DEVELOPMENT ASSESSMENT REPORT

<b>Application No.</b>	D/2019/389
<b>Address</b>	22 Carrington Street, LILYFIELD NSW 2040
<b>Proposal</b>	Alterations and additions to existing dwelling-house, new rear deck, rear pergola and associated landscaping works.
<b>Date of Lodgement</b>	8 October 2019
<b>Applicant</b>	Mr D D L Caroly
<b>Owner</b>	Mr D D L Caroly
<b>Number of Submissions</b>	Nil
<b>Value of works</b>	\$220,000.00
<b>Reason for determination at Planning Panel</b>	Floor Space Ratio variation exceeds officer delegations
<b>Main Issues</b>	Floor Space Ratio variation exceeds 10% Site Coverage variation exceeds 10%
<b>Recommendation</b>	Approval with Conditions
<b>Attachment A</b>	Recommended conditions of consent
<b>Attachment B</b>	Plans of proposed development
<b>Attachment C</b>	Clause 4.6 Exception to Development Standards

Image 1. Proposed rear ground and first floor additions BLZ compared to adjoining properties.

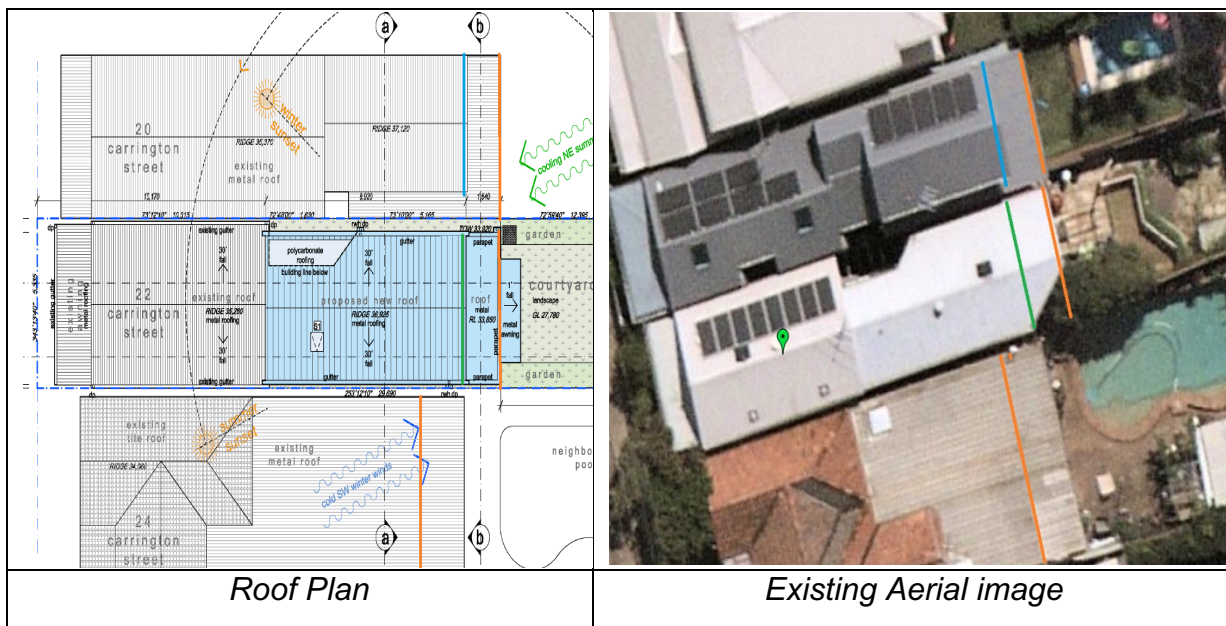
The proposed additional floor area to the rear lower ground and ground floor levels will comply with the Building Location Zone control as it does not extend beyond the existing rear alignment(s).

The proposed rear first floor addition will be in line with the existing rear first floor building alignment of the adjacent property at No. 20 Carrington Street.

As a result, the proposal will establish a new rear first floor building alignment when compared to the immediate adjoining properties as shown in the table below. The orange line as shown below indicates the existing lower ground and ground rear BLZ of the subject and adjoining properties, the blue line indicating existing first floor BLZ and the green line indicating proposed rear first floor BLZ.

As mentioned above, the proposed BLZ variation to the first floor addition to the rear as conditioned is acceptable for the following reasons:

- The proposal will have minimal adverse amenity impacts to the surrounding properties in relation to sunlight, privacy and view loss concerns.
- The proposal as conditioned will be compatible with the existing streetscape, desired future character and scale when compared to the surrounding developments.
- The proposal will also provide adequate private open space, outdoor recreation area and will comply (subject to the recommended conditions) with the maximum site coverage development standard.
